SUBJECT: Forwards response to Generic Ltr 87-12 re loss of RHR while
 RCS partially filled.

Subject: Palo Verde Nuclear Generating Station (PVNGS)
Units 1, 2 and 3
Docket Nos.: STN 50-528 (License No. NPF-41)
STN 50-529 (License No. NPF-51)
STN 50-530 (License No. NPF-65)
Response to Generic Letter 87-12
File: 87-A-056-026

RESPONSE TO NRC REQUEST FOR INFORMATION
ON LOSS OF RESIDUAL HEAT REMOVAL

Figure 1
Permanent Level
Indication System

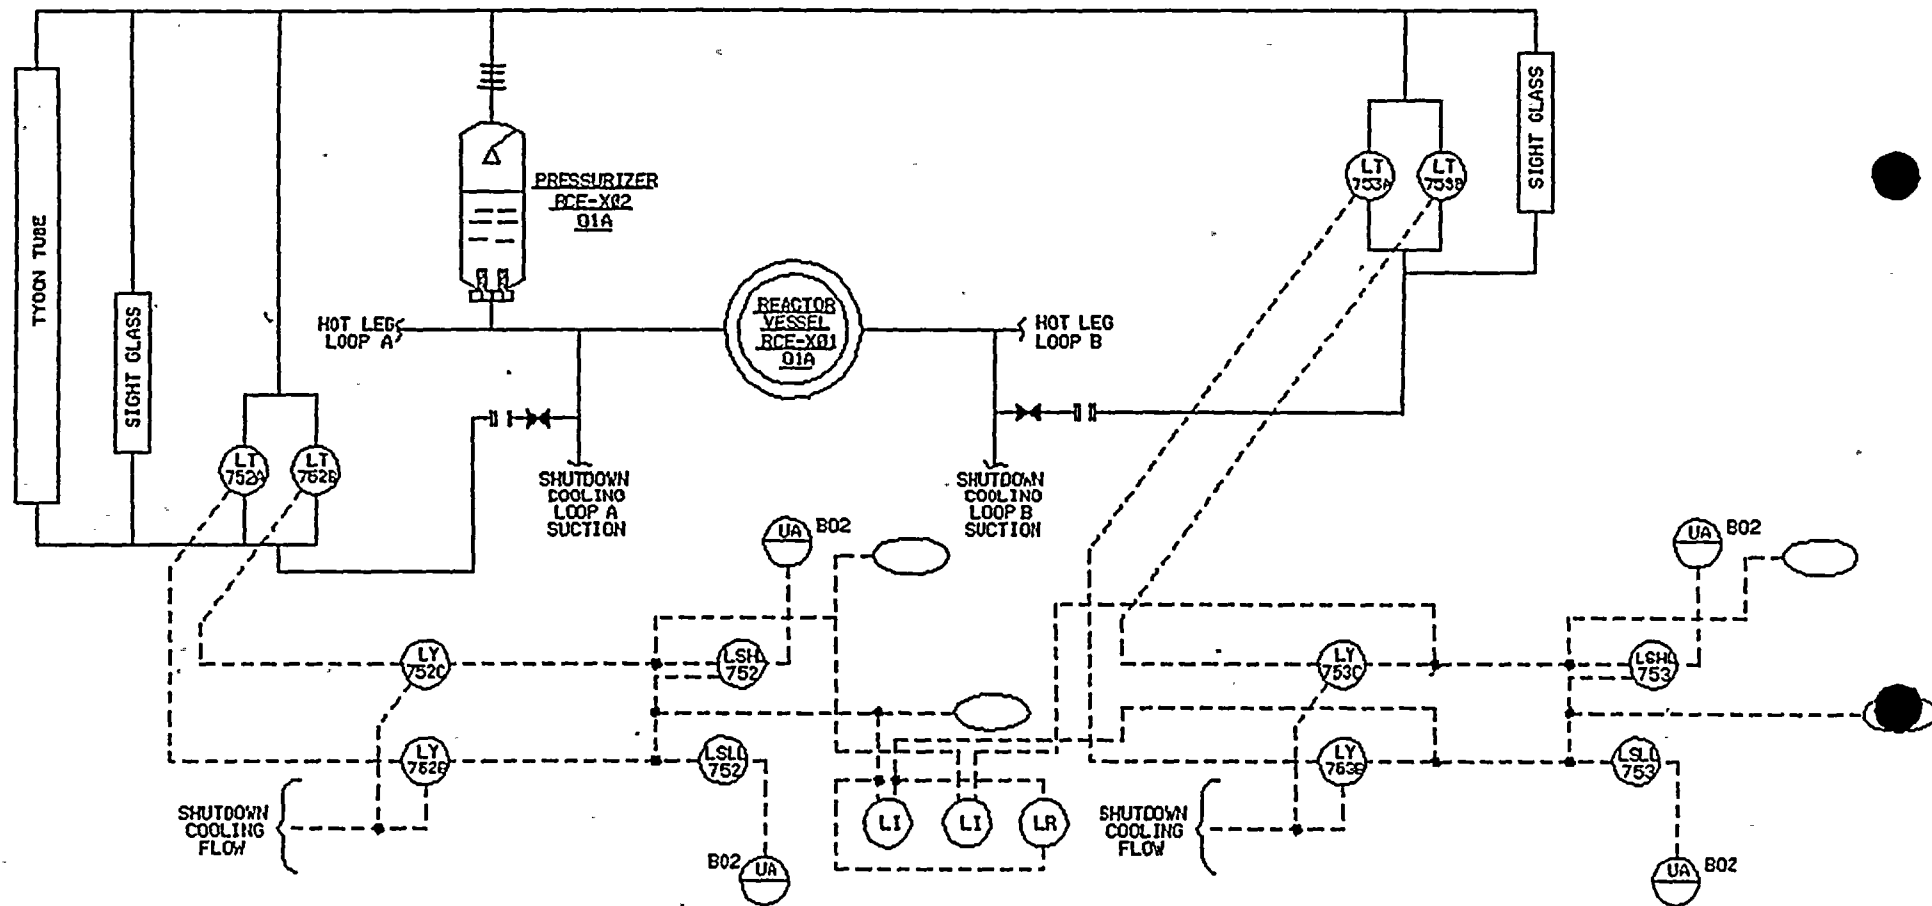
A detailed description of the instrumentation and alarms provided to the operators for controlling thermal and hydraulic aspects of the NSSS during operation with the RCS partially filled. You should describe temporary connections, piping, and instrumentation used for this RCS condition and the quality control process to ensure proper functioning of such connections, piping, and instrumentation, including assurance that they do not contribute to loss of RCS inventory or otherwise lead to perturbation of the NSSS while the RCS is partially filled. You should also provide a description of your ability to monitor RCS pressure, temperature, and level after the RHR function may be lost.

During mid-loop operations, PVNGS currently uses a tygon tube refueling level indication system that consists of a tygon tube which is connected to the SDCS loop A suction line via valve RCN-V214 with the upper end vented to the pressurizer via open vent valve RCN-V058. The installation of this tygon tube level indication system will be governed by a maintenance procedure which provides specific directions as to the length of hose, type of hose, hose connections, and the exact method of routing. By use of this system, the RCS level can be determined locally by inspecting the tygon tube or in the main control room by use of a closed circuit television (when available). ANPP has performed a calculation to determine the consequences of a complete failure of the tygon tube. The failure was assumed to occur at the connection of the tygon tube to the shutdown cooling suction line and the RCS was assumed to be drained to mid-loop with a pressure of 10 psig. The results of the calculation indicate a leak rate of less than 63 gpm from a rupture of the tygon tube. This quantity of leakage is within the makeup capability of either two charging pumps, or one HPSI pump, or one Boric Acid Makeup Pump (BAMP).

Although this tygon tube level indication system will be used during each units next refueling outage (and until such time as the new system is installed), ANPP is also initiating a modification to install a dedicated refueling level instrumentation system in each unit. The proposed system consists of control room level indicators receiving signals from the level transmitters (one wide range, one narrow range) on each hot leg. The level signals are sent to the main control room for display on two level indicators and one level recorder. The signals are also input to the plant computer for trending and to the plant annunciator system for main control room alarm output. The current plans are to provide the main control room with a high level alarm, a low level alarm and a low-low level alarm. Since the redundant systems tap off of the shutdown cooling suction lines, compensation is provided to correct the level signals during operation of the associated SDCS loop. This compensation is accomplished by characterizing the flow signals from the SIA-FT-306 and SIB-FT-307 transmitter loops and summing to the new level indication loop. Although final design work is still in progress, the new refueling level indication system is expected to resemble Figure 1.
